Internal Department	Referral comments (summarised)
Acoustic Engineer	<p>No Objection, subject to conditions.</p> <p>The acoustic consultant (for applicant) has recommended decent glazing along the west façade however it also defers to this being confirmed during detailed design after application approval. For that reason, I recommend conditions similar to:</p> <ul style="list-style-type: none"> • All habitable rooms shall be designed to comply with Clause 58 (Standard D16) of the planning scheme. Prior to occupation of units, an acoustic report detailing testing within habitable rooms over a reasonable sample of units shall be provided to the satisfaction of the Responsible Authority confirming that the minimum internal noise levels have been met. Any further rectification to ensure compliance shall be at the cost of the applicant. <p>The only risk that has not been addressed (because there is no access yet) is once the proposed tower gets to a height above adjacent building rooftops, there may be noisy mechanical plant on those roofs that are an issue. This is hard to say now however I know it has been a problem for a couple of other developments along Queens Rd that overlook exis

Plan of balconies on either side of vertical articulation – suggested privacy screen location marked up in yellow/red.

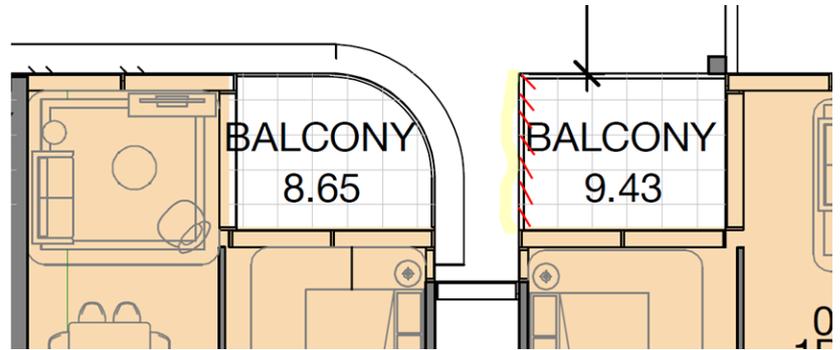
However, the revised plans have created a new residential amenity issue: balconies of separate dwellings face each other across the 2 vertical articulation gaps. Refer figures below.

It is considered appropriate to resolve this issue through a condition of approval. For example, a 1700 high thin metal vertical privacy screen, either solid, glazed or with vertical louvres, would achieve privacy on the side of the rectilinear balcony. If the materials and colours are integrated with the balcony, it would not be considered to detract from the facade composition or building articulation.

1. Provide privacy screen to the balcony on one side of the Queens Lane vertical articulation break, with detailing, materials and colours integrated into the overall façade design.

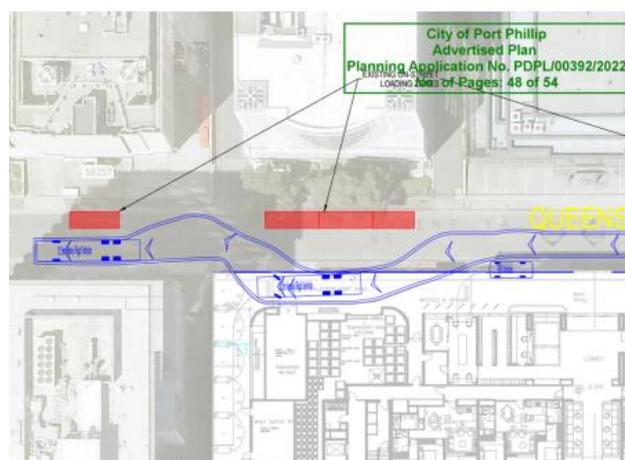
The ground level of the Queens Lane frontage has been modified to remove the 'shared zone' treatment and introduce a typical 150mm kerb along the existing alignment but with indented pick-up/drop-off for four vehicles in front of the main entry. Pedestrian pavement is shown as textured stone in multiple shades of grey.

This should be confirmed as sawn, locally sourced bluestone.

The proposed change to the general layout is appropriate as it removes some of the ambiguity between pedestrians and vehicles evident in the previous scheme.

However, the detailed plan on page 19 of the Arcadia Landscape Architectural Town Planning Report indicates a 'loading zone' on the northern end of the footpath in front of the bin store. The traffic report includes this and shows a swept path for a waste collection Heavy Rigid Vehicle traversing across the pedestrian path to park in the area in front of the bin store. We recommend confirmation of the adequacy of stone pavement and kerb profiles for this area to ensure they can accommodate and are not damaged by frequent and regular heavy truck access for waste collection.

We note that the landscape plans do not show details for vehicle crossovers in this area which should be confirmed. We also recommend confirmation of details to ensure safety for pedestrians during the collection of waste.
